Consumers Power Company
Palisades Plant
Docket 50-255

PROPOSED TECHNICAL SPECIFICATIONS PAGE CHANGES
SPENT FUEL POOL STORAGE CAPACITY EXPANSION

SPENT FUEL STORAGE
MODIFICATION

SAFETY ANALYSIS REPORT

FIGURE 5.4-1
SPENT FUEL POOL ARRANGEMENT

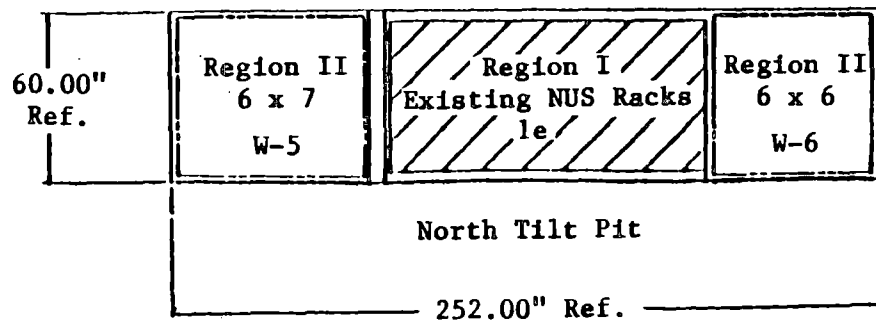
- d. Region II racks have a 9.17 inch center-to-center spacing. Because of this smaller spacing, strict controls are employed to evaluate burnup of the fuel assembly prior to its placement in Region II cell locations. Upon determination that the fuel assembly meets the burnup requirements of Table 5.4-1, placement in a Region II cell is authorized. These positive controls assure the fuel enrichment limits assumed in the safety analyses will not be exceeded.

- e. After installation of the two-region high density spent fuel racks, the maximum loading for fuel assemblies in the spent fuel racks is 3.27 w/o of U-235.

- f. The minimum spent fuel pool water boron concentration shall be 1720 ppm. Boron concentration shall be verified at least once monthly.
- g. The spent fuel racks are designed as a Class I structure.

- i. Storage in Region II of the spent fuel pool and spare (north) tilt pit shall be restricted by burnup and enrichment limits specified in Table 5.4-1.

NOTE: Until needed for fuel storage, one Region II rack in the northeast corner of the spent fuel pool may be removed and replaced with the cask anti-tipping device.
